Planning application 2024/1175/P was registered on 17/05/2024.

The application seeks permission for demolition of an existing garage and the erection of a new 2 storey dwelling on land to the rear of 172 Regents Park Road.

Amended drawings have been submitted by the applicant dated 25th October and I am now writing to further OBJECT to the revised application.

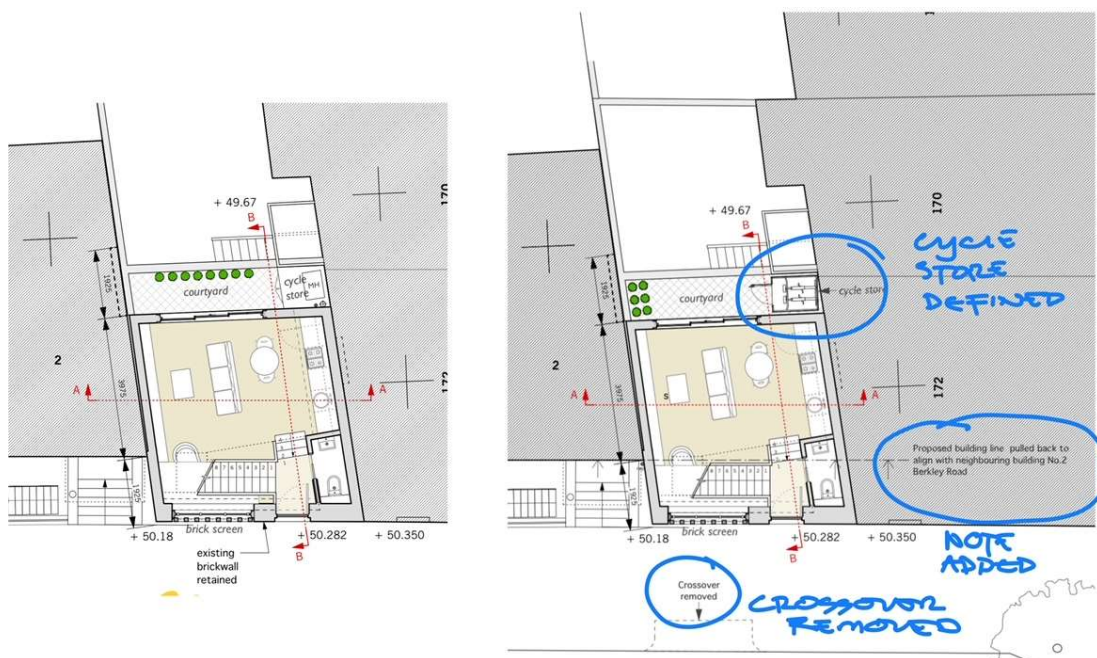
In addition to the above, I note that the drawings are confusing insofar as on the first floor plan, an area of "Flat roof" is annotated above the proposed kitchen. The whole of the ground floor outside the first floor footprint is of course covered in a flat roof, not just this annotated area.

Are we to surmise that this annotation is indicating an area of glazed roof above the kitchen? If so it presents a fire, privacy and noise risk to the neighbouring flats in 172 Regents Park Road.

As originally submitted

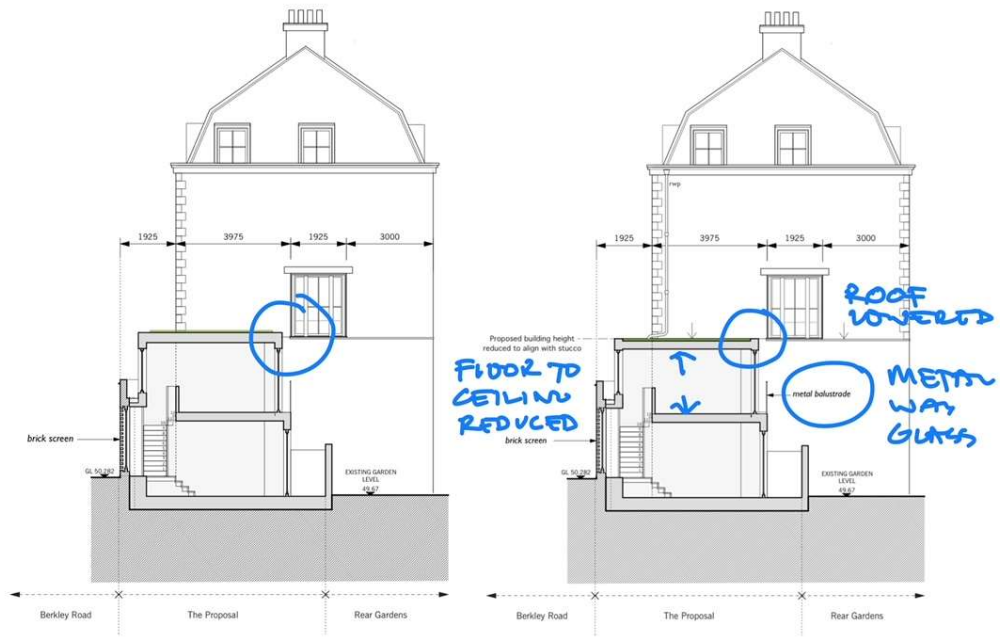
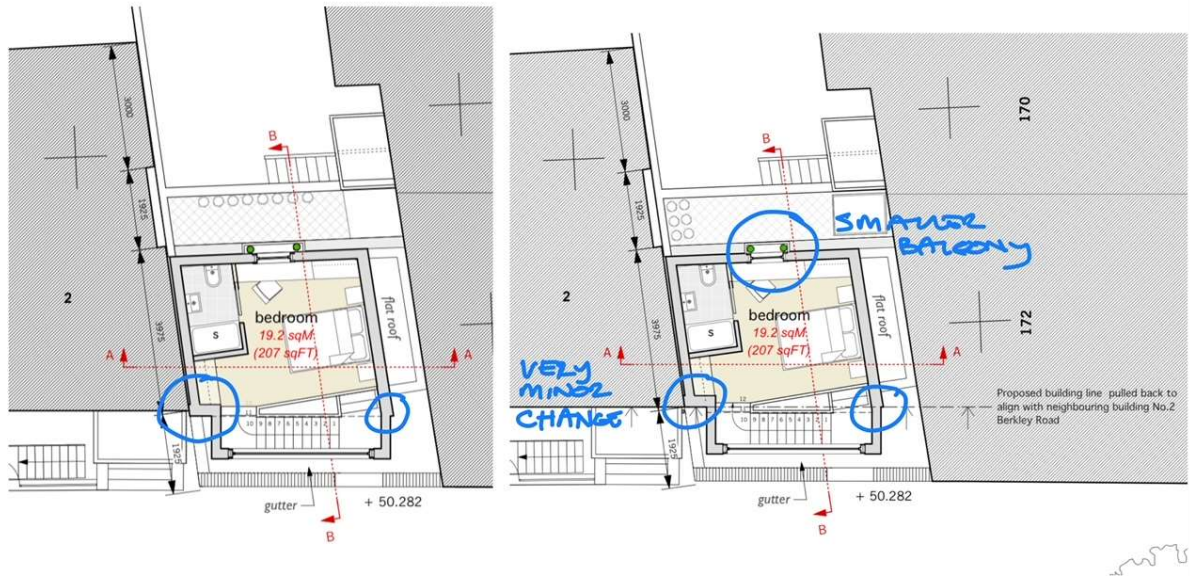
3. Proposed building line to Berkley Road elevation pulled back to align with 2 Berkley Road. I do not object to the principal of this change aesthetically, but it should be noted that the annotated floor area on the drawing has not been amended but the change will marginally reduce the floor area of the development which is already extremely small.

4. Omitting glass "french balcony" and replacing it with metal railings. It should be noted that in so doing, the size of balcony has been reduced.
5. Reduction in height of parapet to align with the stucco of 2 Berkley Road. Whilst I do not object to the principal of the change aesthetically, the practical consequence is a reduction in the floor to ceiling height of the proposed residential accommodation. The drawings are not dimensioned, so it is not possible to know if the room now conforms to the minimum 2.5m height sought in new residential developments in London. I doubt that it can. Accurate and fully dimensioned construction sections should be sought that prove the deliverability of adequate residential standards.
